Fire fighting alarm in Gardner/Snyder Thermal Power Station is centralized at S-1 & S-2 central control room, however, almost all the alarm are defective.

2) Malaya Thermal Power Plant

Fig. 5M-23 VARIABLE PRESSURE OPERATION

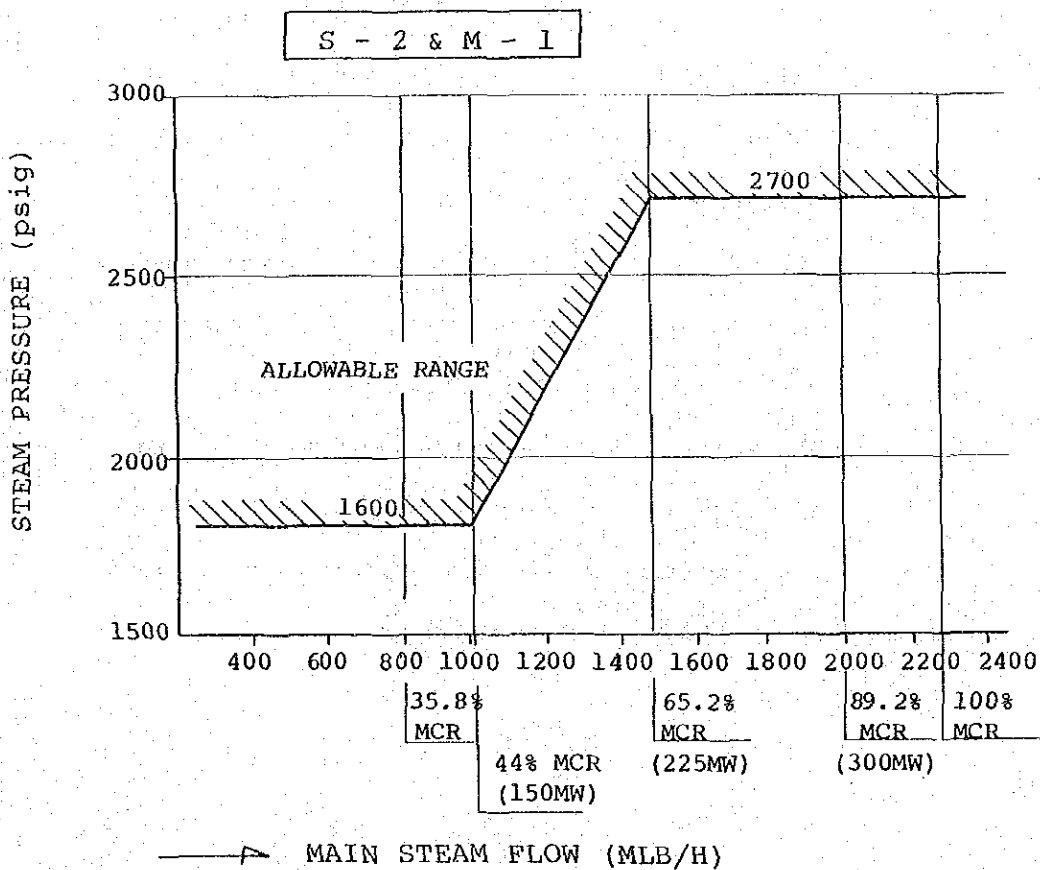
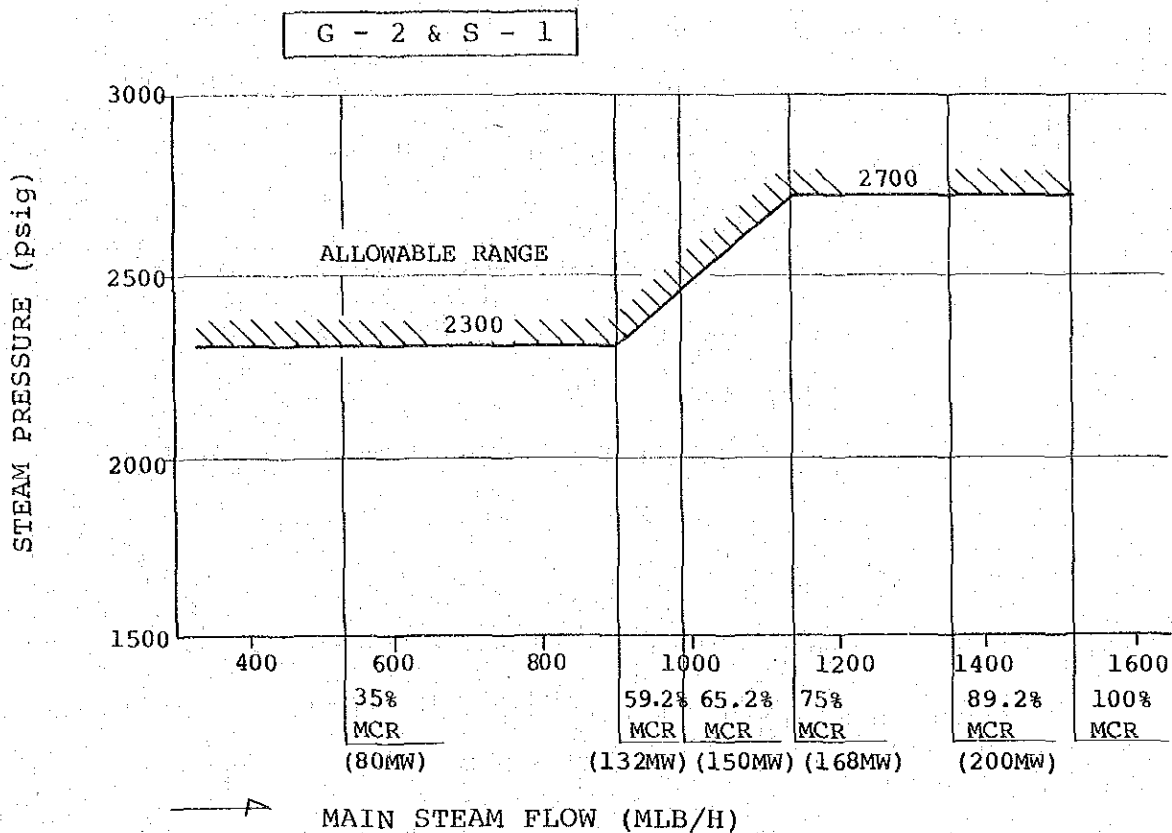
For once-through boiler, NAPOCOR should be extra careful for the flow of fluid in the boiler tubes. According to the manufacturer's report on variable pressure operation, correlation between boiler pressure and steam flow is very important. If NAPOCOR carries out a careless operation under a variable pressure operation, the boiler will suffer a serious damage.

In the case of M-1 is on variable pressure operation at 2100 psig and a maximum load of 240 MW. Under this pressure the maximum load must be kept less than 175 MW in accordance with the manufacturers recommendation.

Therefore, JICA team would like to recommend for NAPOCOR to strictly carry out and follow the recommendations for variable pressure operation by the manufacturer.

Fig. 5M-24 CONDITION OF AH AVE. TEMPERATURE AND DIFF. PRESSURE FOR M-2

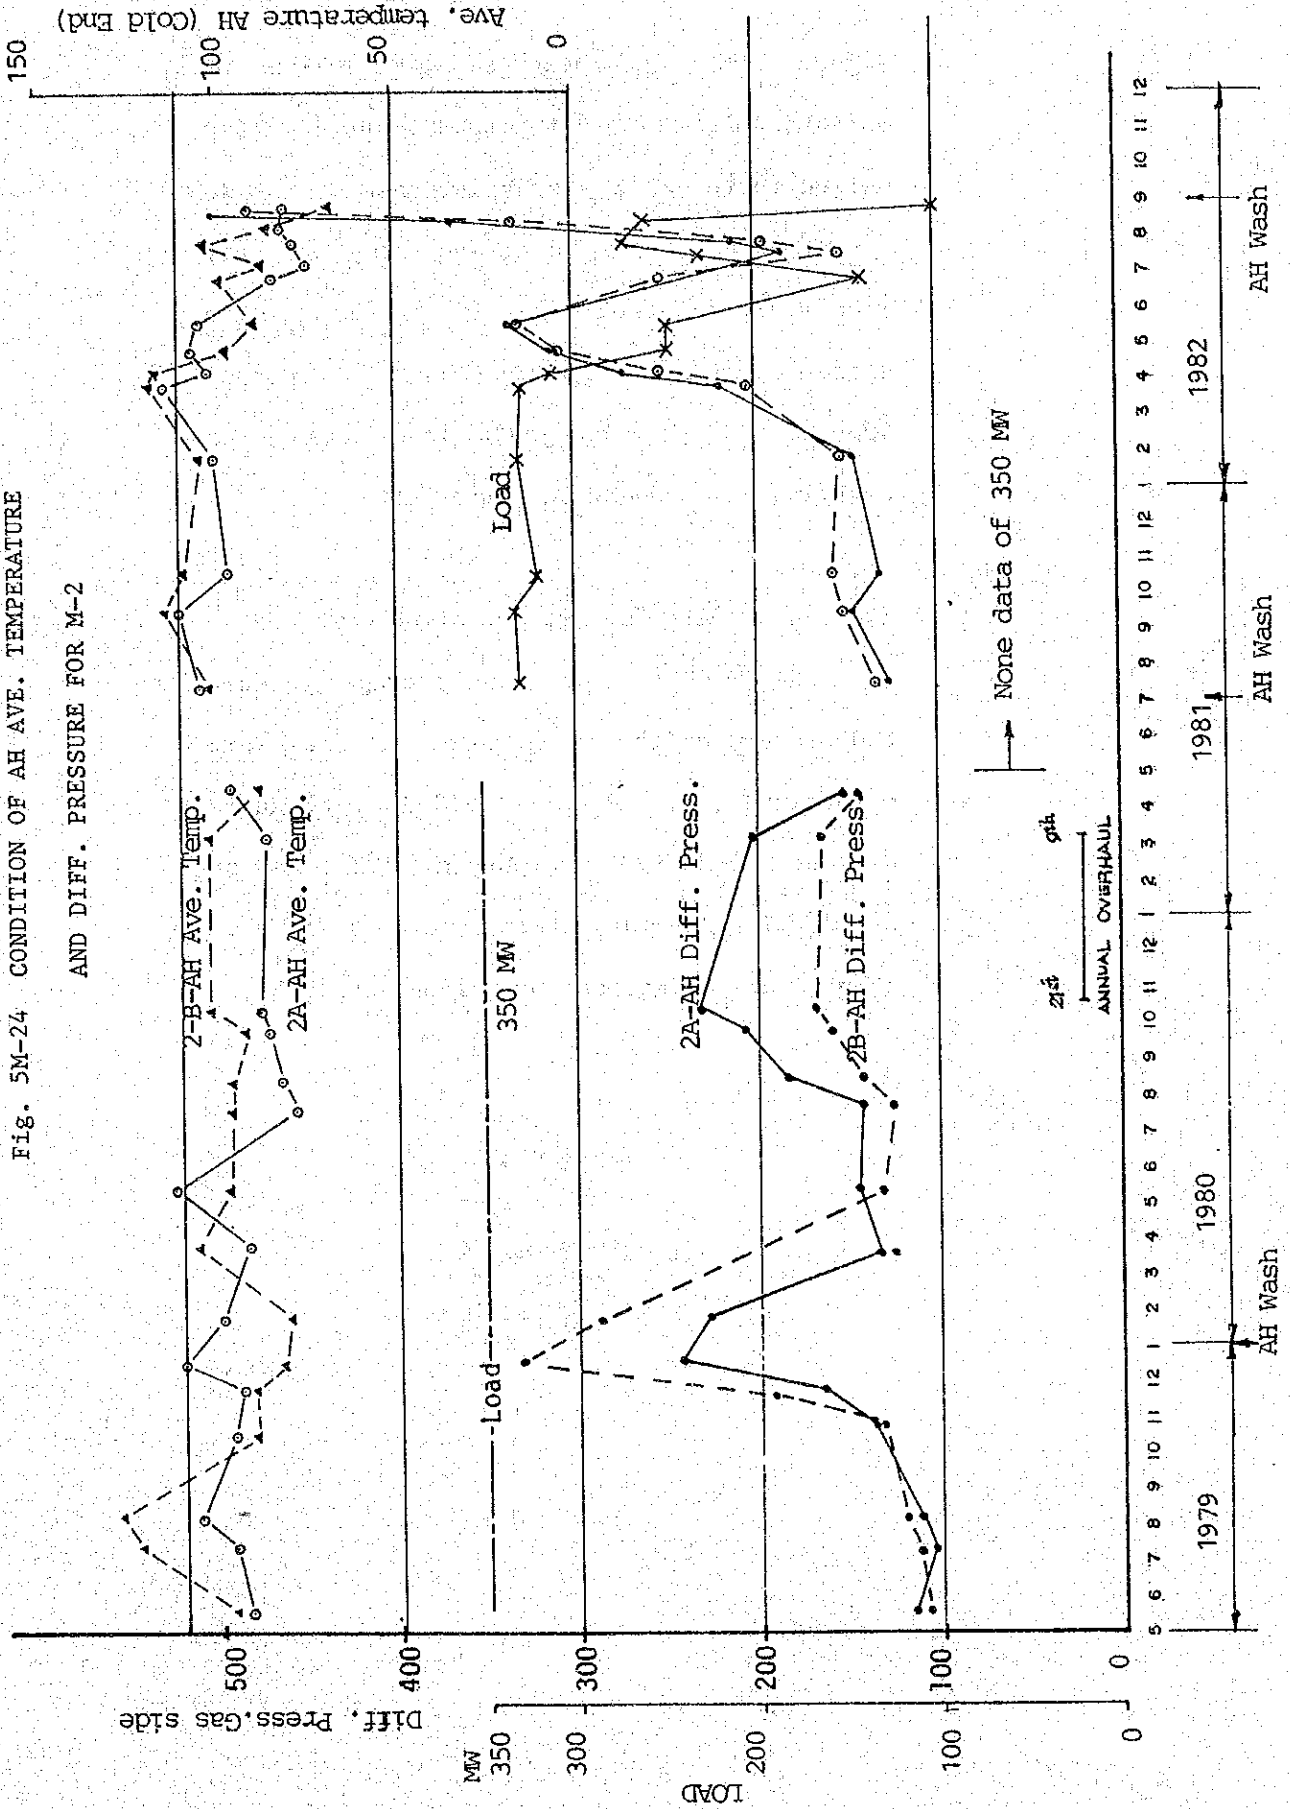
M1 and M2 has a very big air preheater corrosion problem. Most especially M-2 which is in a very critical condition as shown in Fig. 5M-24.

Before commercial operation the differential draft of the AH was kept between 100 and 120mm H₂O at 350 MW. This differential draft increased from Oct. 1979 and reached its peak in December 1979. AH washing was conducted and this reduced the differential draft to less than 120 mm H₂O. AH washing was again carried out at least three (3) times before the annual overhaul of the unit. During this period before overhauling, the unit was able to carry its rated load of 350 MW.

The period where the average gas-air temperature of the AH cold-end elements were maintained to more than 110°C is very short between May 1979 to August 1982. Most especially 2A-side which operated at low temperature condition for a long period.

Fig. 5M-27 EXISTING M-1 SCAH OPERATION

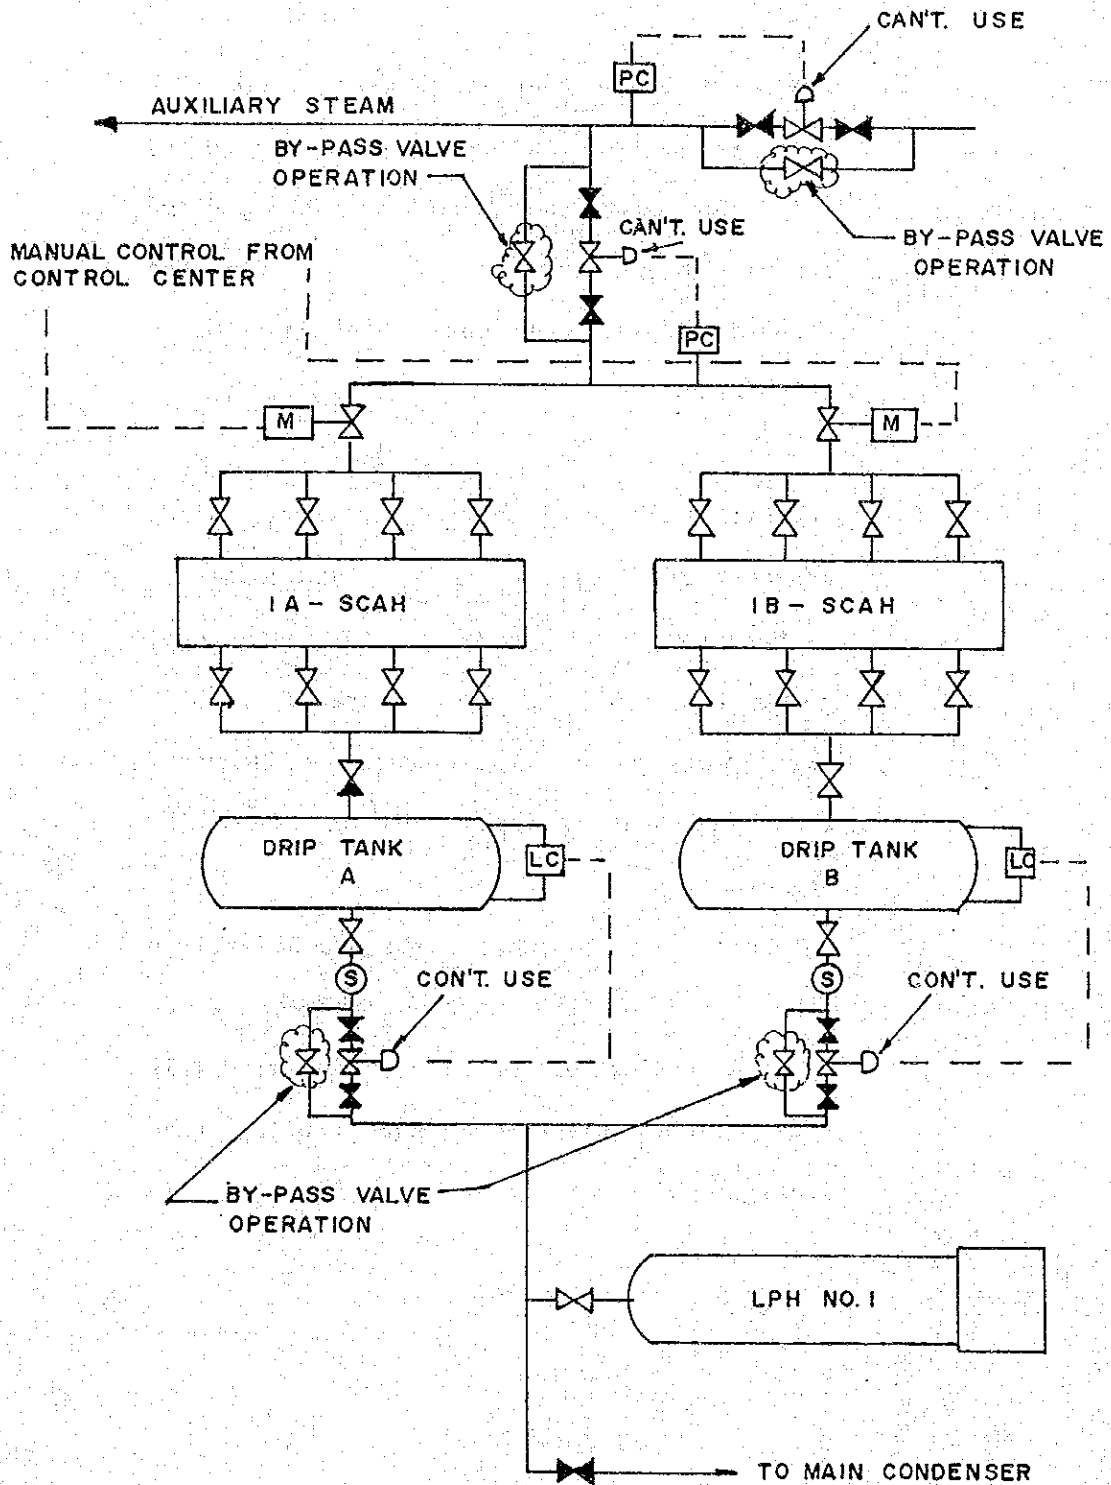
ii. Existing State of M-1 SCAH

- (i) Immediately repair/replace the defective control system for the auxiliary steam supply of the SCAH.
- (ii) Immediately repair/replace the temperature control system of the SCAH and always use it on automatic operation.
- (iii) Immediately repair/replace the level control system of the drip tanks A & B.

Fig. 5M-29 EXISTING M-2 SCAH OPERATION

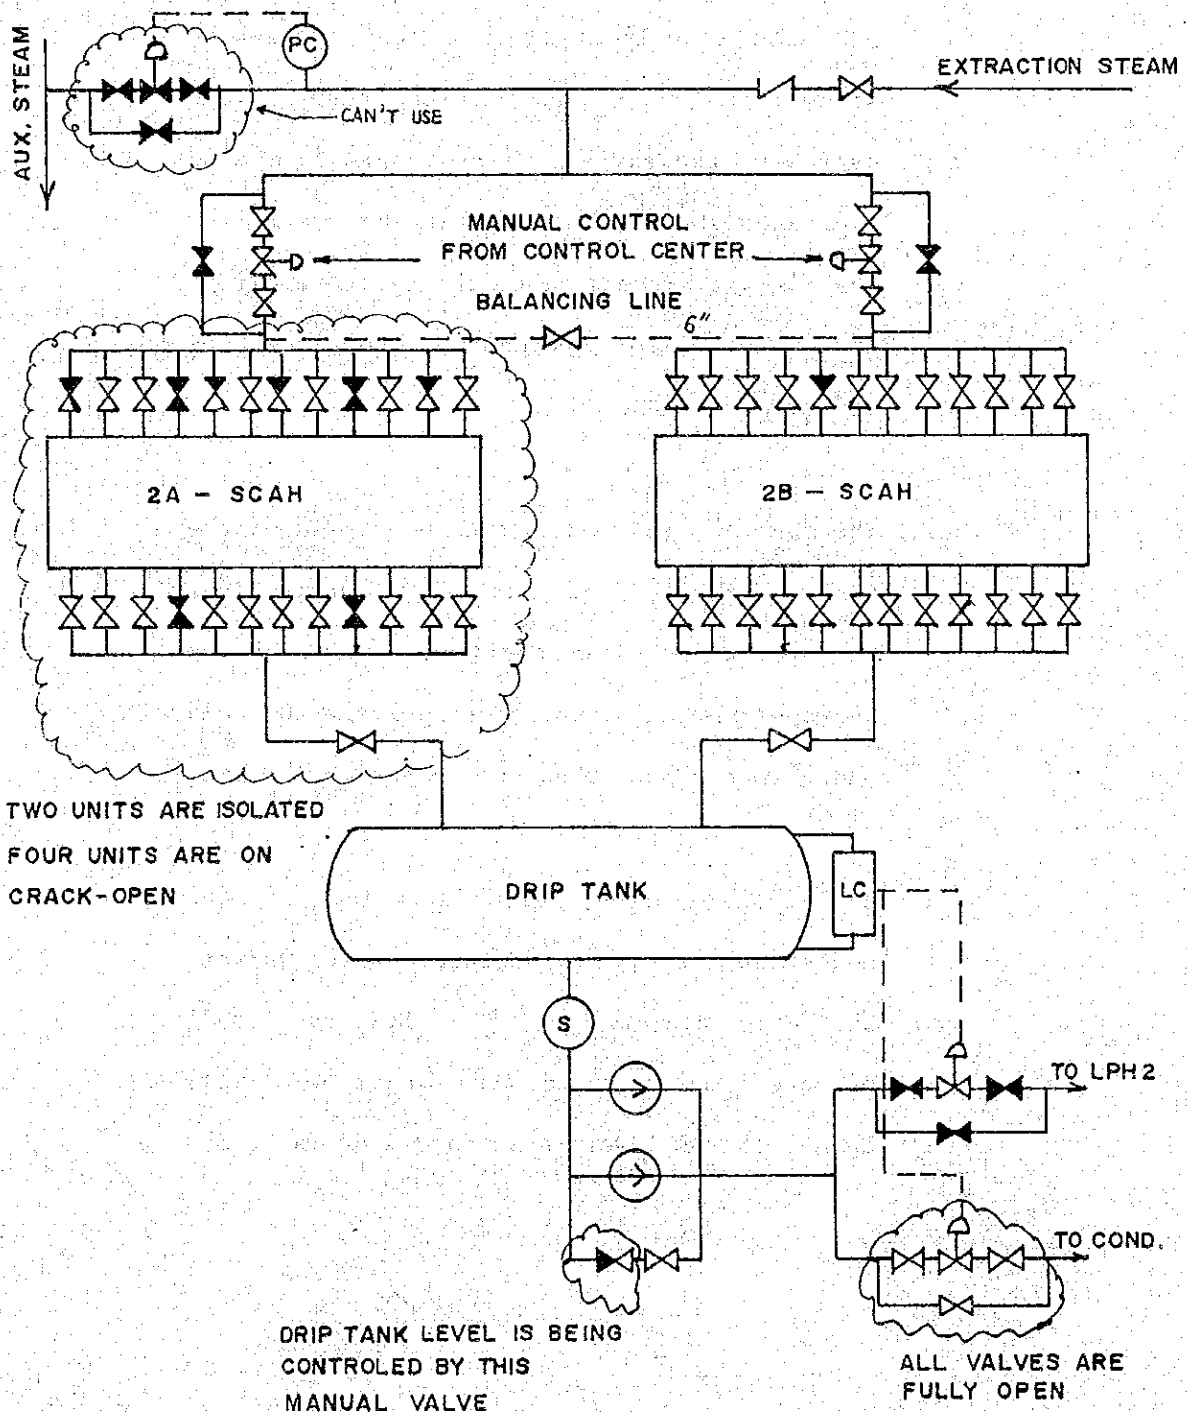
(iii) A balancing line, was installed at the downstream of the temperature control valves. The pipe diameter is 6". But even this balance line is used, the steam flow will change in the lower resistance side (A or B).

(i) Immediately repair/replace all defective control system of M-2 SCAH as to heating steam pressure control, temperature control, level control, etc.

(iv) To close the valve of the balancing line.

Fig. 5M-30 PREFERABLE SCAH SYSTEM

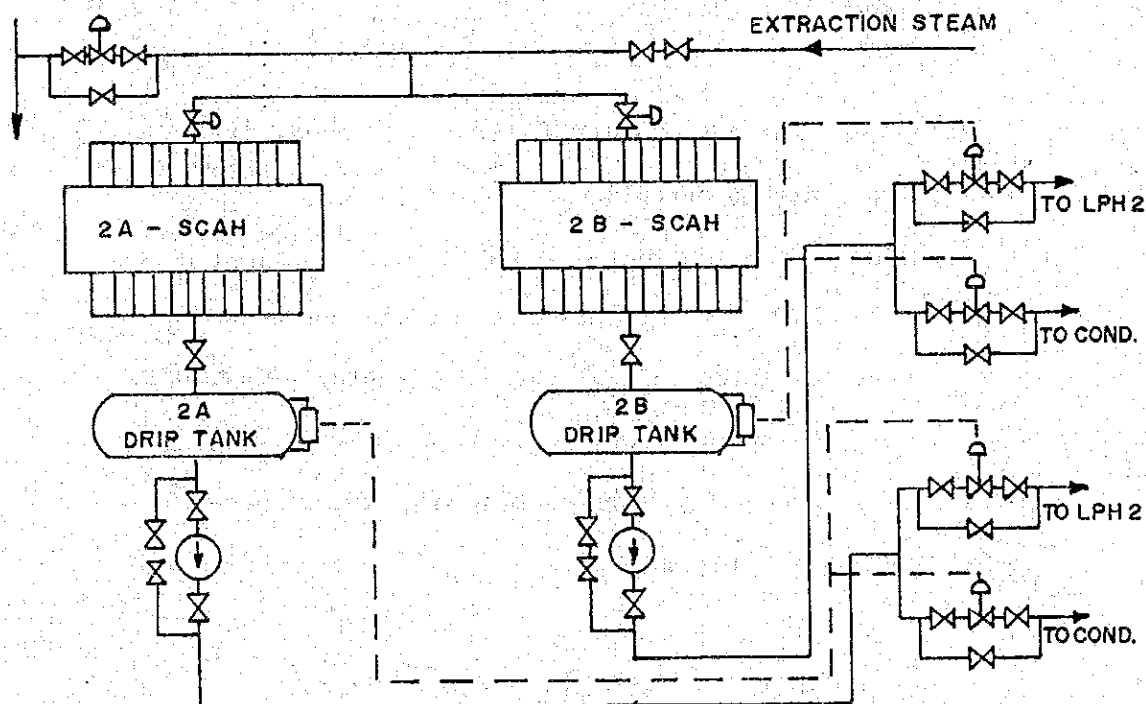
(iii) To improve the drip tank by this improvement:

Fig. 5M-31 CRH DRAIN LINE

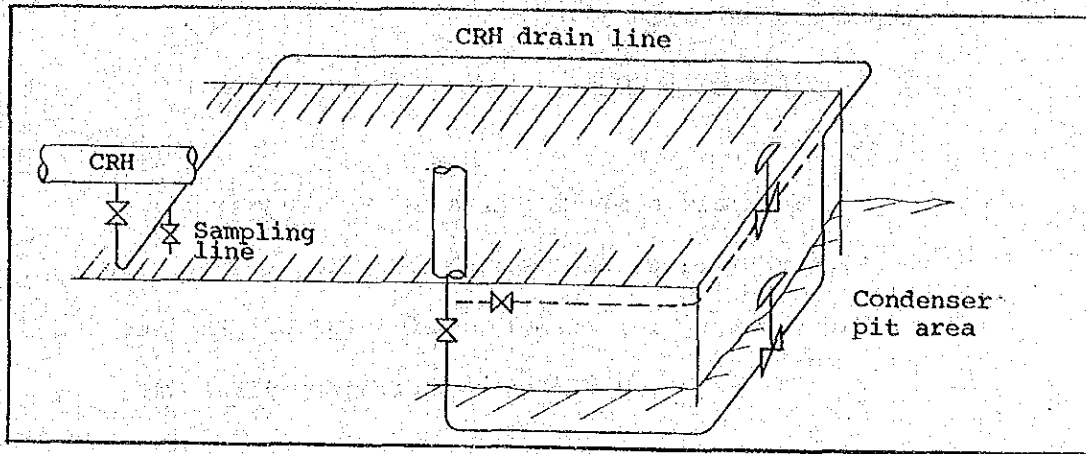
- (i) To replace chlorine detector system with new one. (M-2)
- (ii) To always keep the condenser pit clean (M-1 & M-2)
- (iii) To carry out routine preventive maintenance for condenser sump pumps. (M-1 & M-2)
- (iv) To install chloride detector system on M-1 hotwell tank.
- (v) To improve the condition of the CRH drain line by adopting the following; (M-1)
